Skyview Crossing at Tiffany Springs

Development Plan

NPD Committee

May 6, 2025

S Remove Conditions #9 & #28 – Off-site Water Main Stub

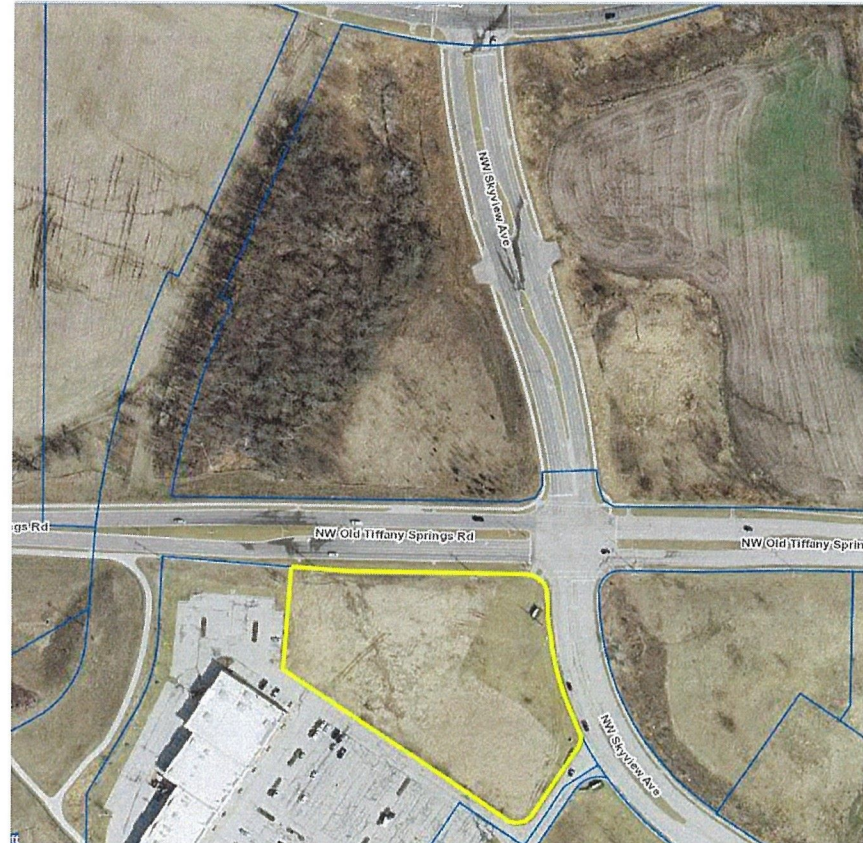
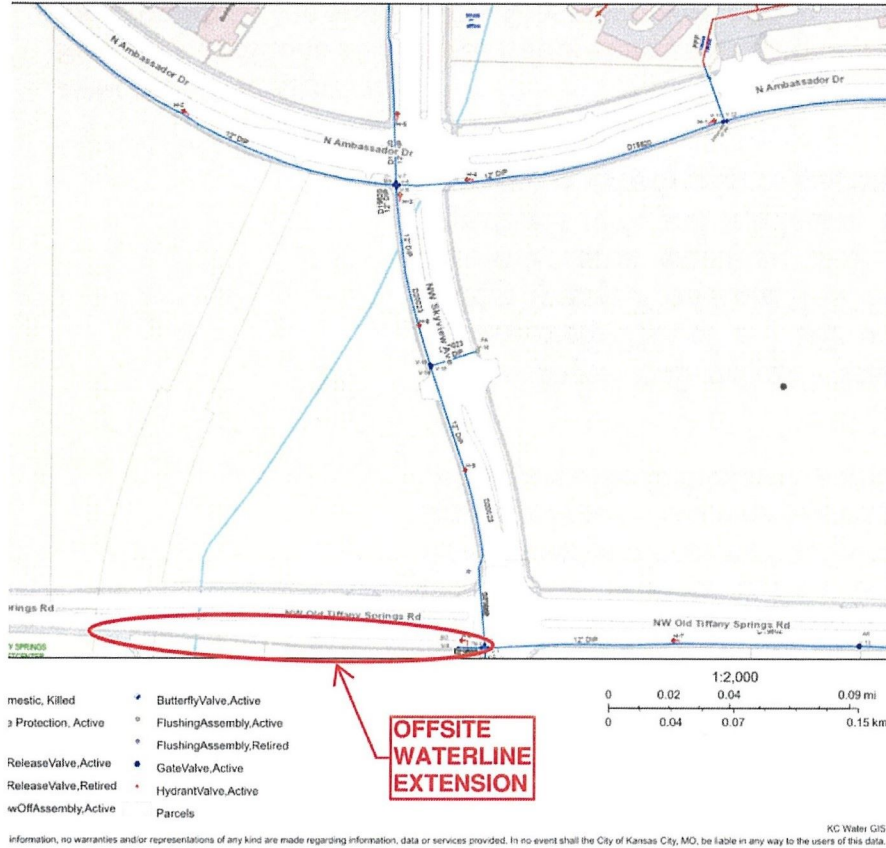
9. The applicant shall revise the plans to satisfy the Water Services Department corrections to revise the deviation note on the cover to request not installing the extension of approximately 750' of 12" DIP public water main with fire hydrants along N.W. Old Tiffany Springs Road between N.W. Skyview and the western property line. (The text in the note that this main extension would not serve this development is not accurate as the requested main extension provides a portion of the looped connection west toward the transmission main which when completed will improve the distribution system reliability and redundancy.)

28. The developer shall submit water main extension plans for the extension of approximately 750' of 12" DIP water main and fire hydrants along N.W. Old Tiffany Springs Road from N.W. Skyview Avenue to the western property limits. The water main extension shall follow all the Kansas City Water Services Department rules and regulations for water main extensions and shall be under contract (permitted) prior to building permit issuance.

Remove conditions #9 and #28 (requesting an additional 750' of off-site waterline extension, which only benefits the property to the south). The City recently re-constructed Old Tiffany and elected not to install a new waterline at that time.

In 2006, the vacant land parcel was part of a larger 74 acre rezoning and development plan approval, Case No. 6029-GP-1. There is a general condition to extend watermain connections in Ord. No. 061287. We don't think the 750' watermain extension condition is proper for our project for several reasons:

1. Skyview Crossing sits north of NW Old Tiffany Springs Road, and we intend to use existing watermain connections from the 12" watermain on the west side of Skyview, the 12" main on the south/west side of Ambassador, and the 12" main of the south side of Old Tiffany Springs. This existing watermain loop has the capacity to provide service.

2. Water Services is asking for a 750' main extension stub on the south side of Old Tiffany Springs Road on the Vacant Land Parcel. This stub would not be operational, and would not connect to the 24" watermain on the east side of I-29. The request is not proportional to the impact that Skyview Crossing has on City infrastructure.

3. The Vacant Land Parcel is not owned by us. The obligation to install this 750' watermain stub should be a condition of development on the owners of the Vacant Land Parcel.

4. We would be willing to include the 750' watermain extension in the Skyview Crossing CID to reimburse the City and/or the owner of the Vacant Land Parcel on a subordinated basis.
